# CITY OF ALBUQUERQUE

**RE: Mercado El Milagro - Buildings G1 and G2  
10000 Central Ave SW  
30-day Temporary Certificate of Occupancy  
Engineer's Certification Date: 10/31/25  
Engineer's Stamp Date: 03/28/2024  
Hydrology File: L09D042B  
Case # HYDR-2025-00394**

G1 GRADING & DRAINAGE PLAN

G2 GRADING & DRAINAGE PLAN

SHEET NO:  
**CG1.1**

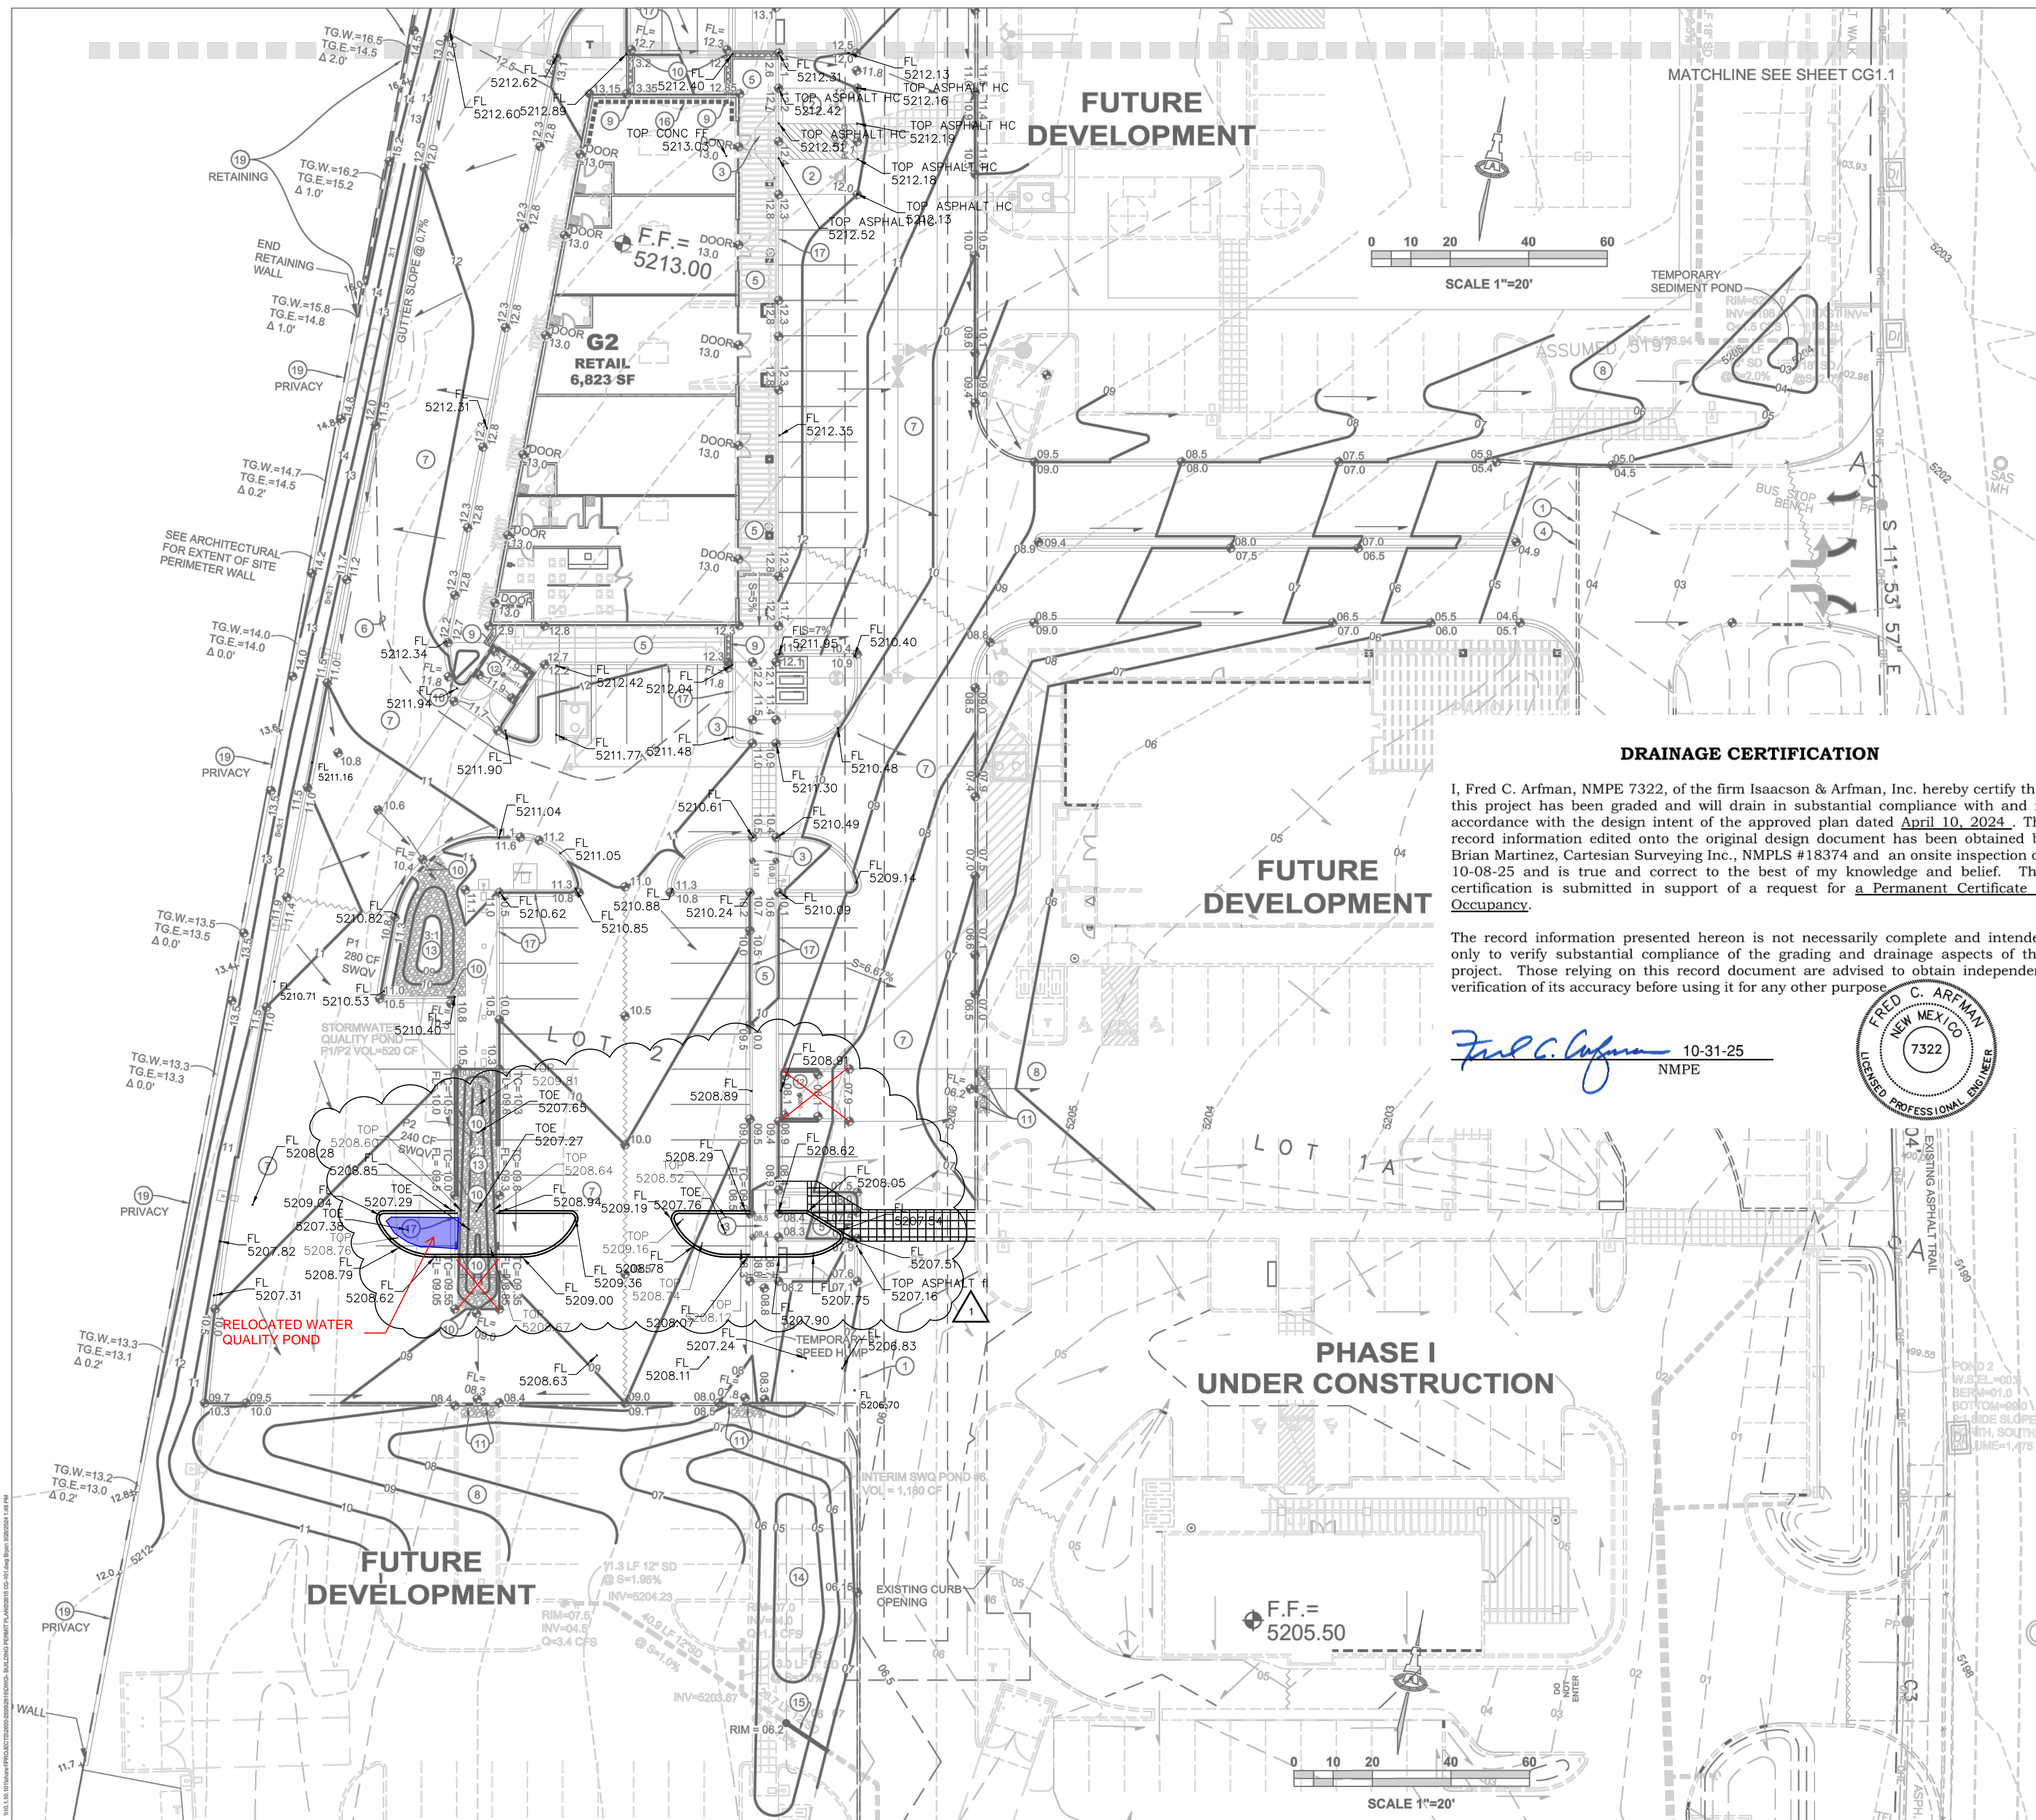
1. Please provide the Drainage Covenant with Exhibit A for the stormwater quality ponds per Article 6-15(C) of the DPM prior to Permanent Release of Occupancy. Please submit the original copies along with the \$ 25.00 recording fee check made payable to Bernalillo County.
